Construction Industry Coalition on Water Quality

November 19, 2014

RE: Comment - Tentative Order No. R9-2015-0001, Place ID: 658018LWalsh

Photo 1 – La Jolla Landslide (Ardath Shale Formation, Claystone, Hydrologic Group D)

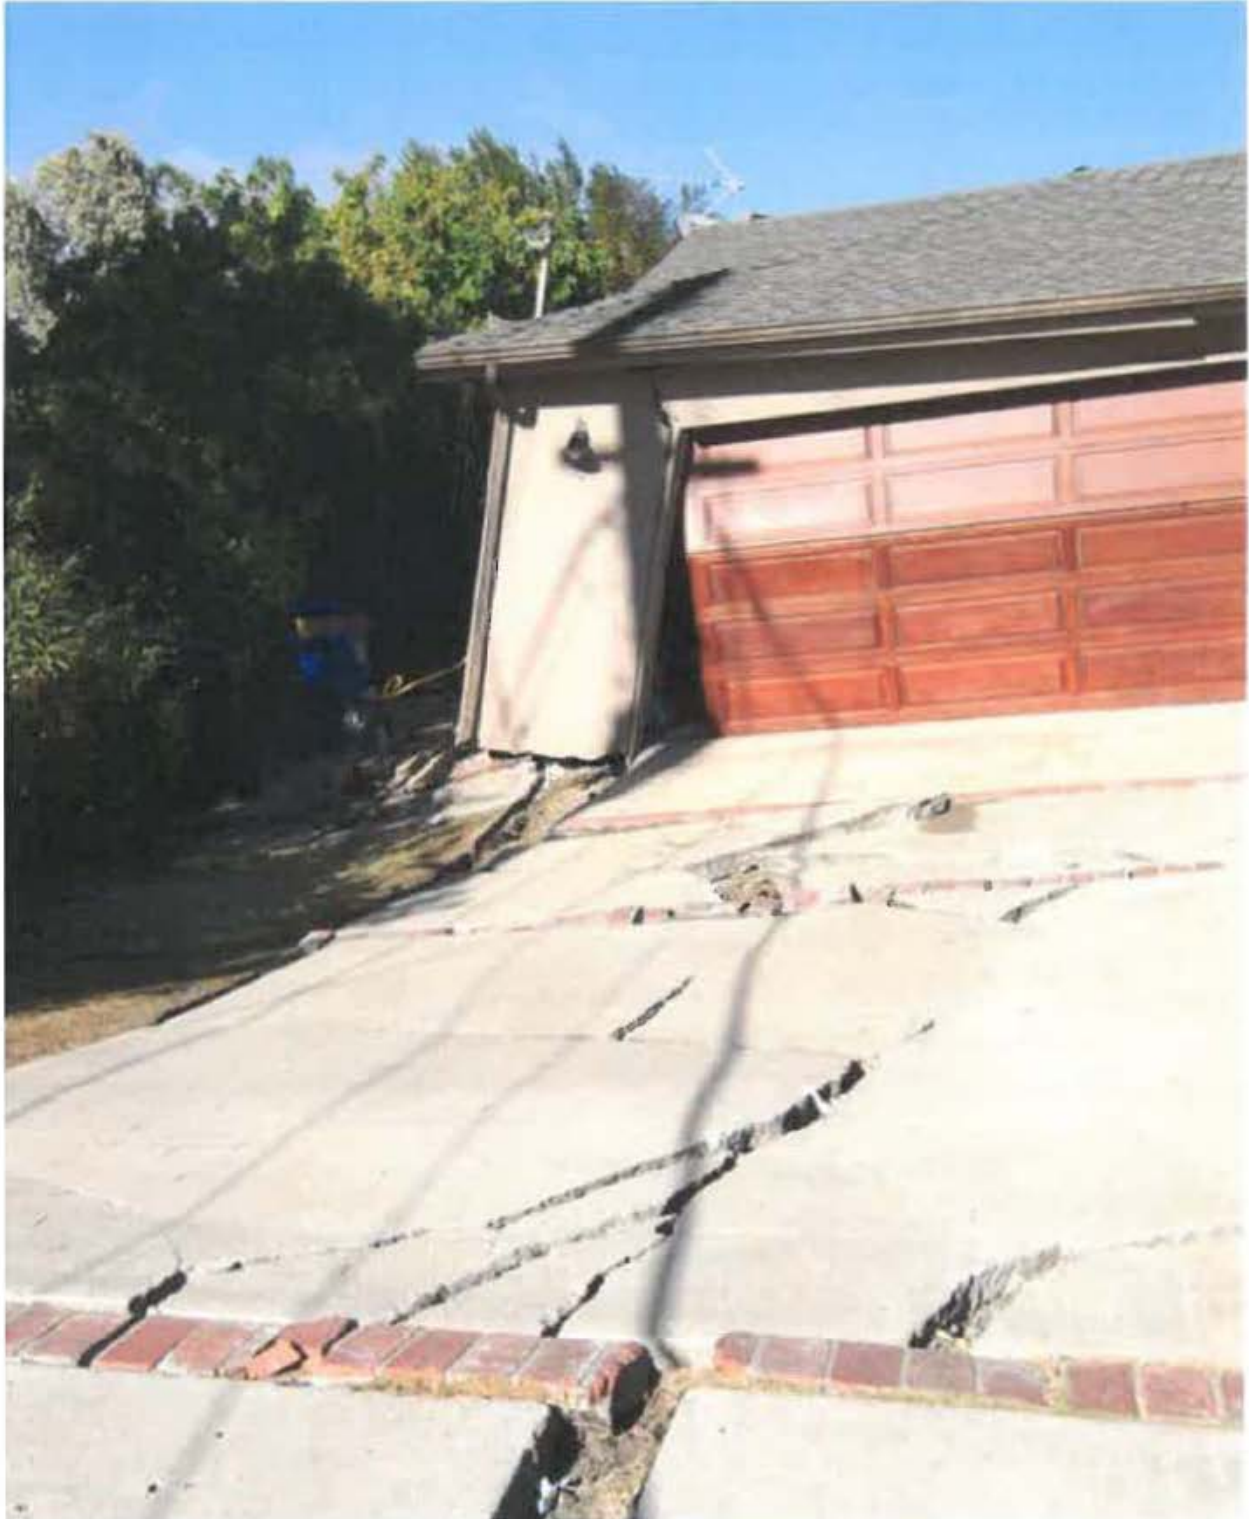
The soil types in Region 9, and particularly San Diego County, are likely infeasible for infiltration where stormwater could eventually reach the underground aquifer. More than 70 percent of the soil types found in San Diego County possess a Soil Hydrologic Group classification of C and D (USDA, 1973). A large majority of the land area possesses a classification of C or D (SANDAG, 2007) and soft/hard rock (CGS, 2007). Using infiltration as a preferred method of stormwater remediation county-wide, therefore, is unsupported. Clearly stated, in the appropriate soil type, infiltration is a preferred alternative. In the wrong soil type the results could be catastrophic. (See photos 1 & 2).

Photo 7 mid-rise condo project at the NW corner of 4th and Nutmeg, San Diego

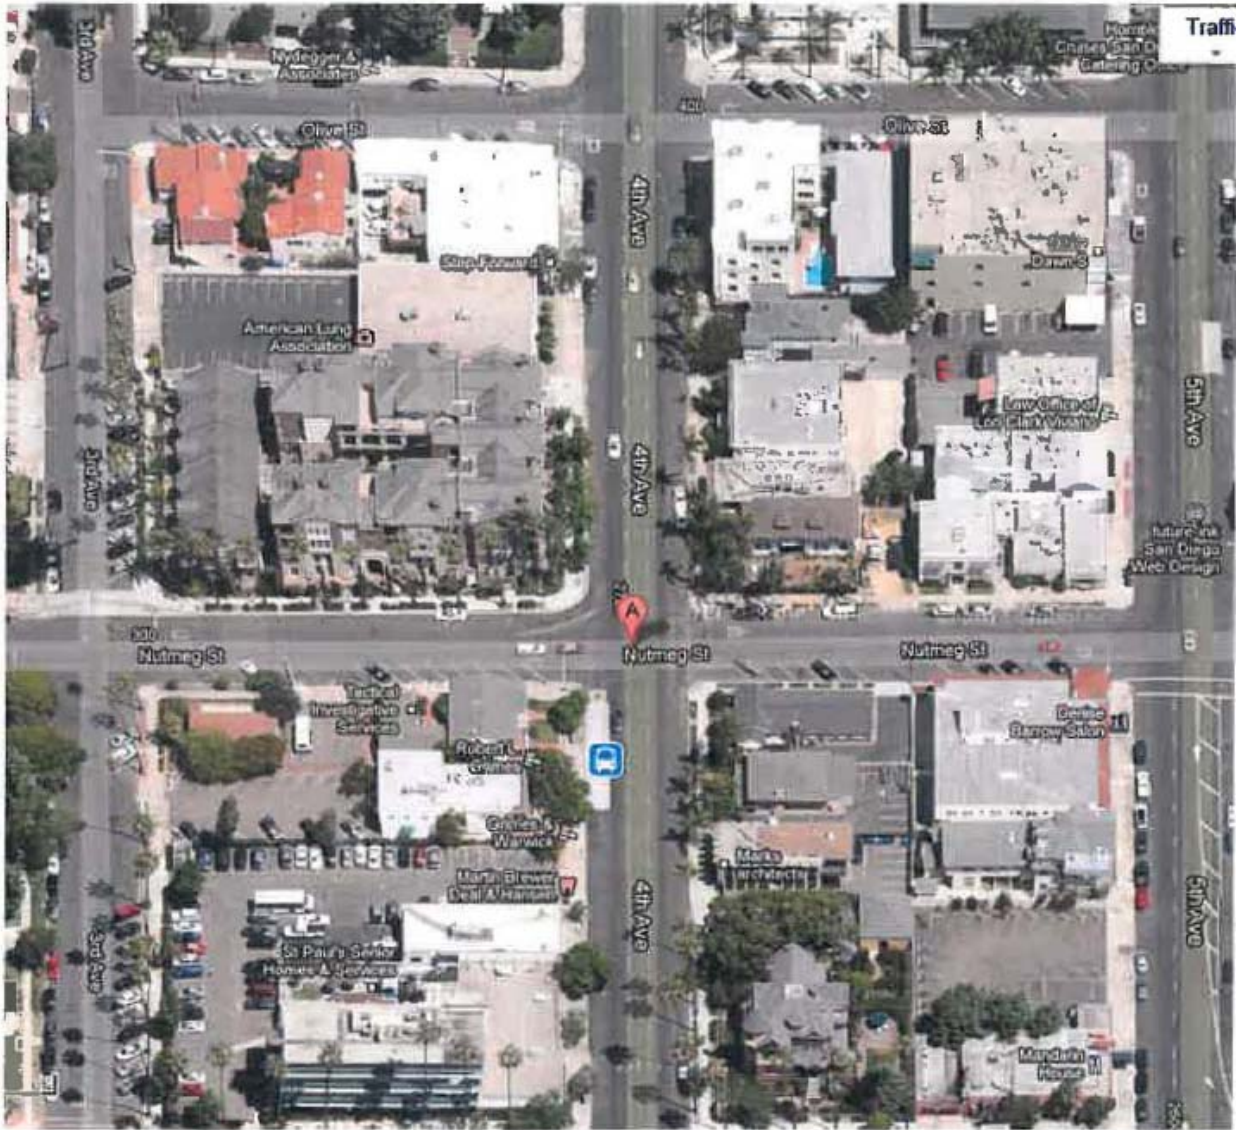
The result is to encourage growth to occur inwards into the existing urban footprint. This is defined as “in-fill” development. An unintended consequence of the Revised Draft Permit is that its requirements actually make it more attractive and cost effective to build away from the existing urban footprint because of the land necessary to comply with the new requirements in the Revised Draft Permit. The 100% pollutant capture requirement and the removal of

hydromodification exemptions on infill development render these projects both technically and financially infeasible. (Refer to photograph 7.)

Photo 7 shows a smart growth project on the northwest corner of 4th & Nutmeg in San Diego's highly urbanized Banker's Hill neighborhood: transit friendly (transit oriented development, TOD); walkable neighborhood; near parks, shopping and recreation (2 blocks from Balboa Park); near San Diego's airport; near Downtown/Hillcrest/Mission Valley work environments; and within the Smart Car (car 2 go) user footprint. Under the Revised Draft Permit, this project would become infeasible because of the 100% pollutant capture (infiltration/reuse) requirement and the loss of the hydromodification exemption previously included in the HMP.
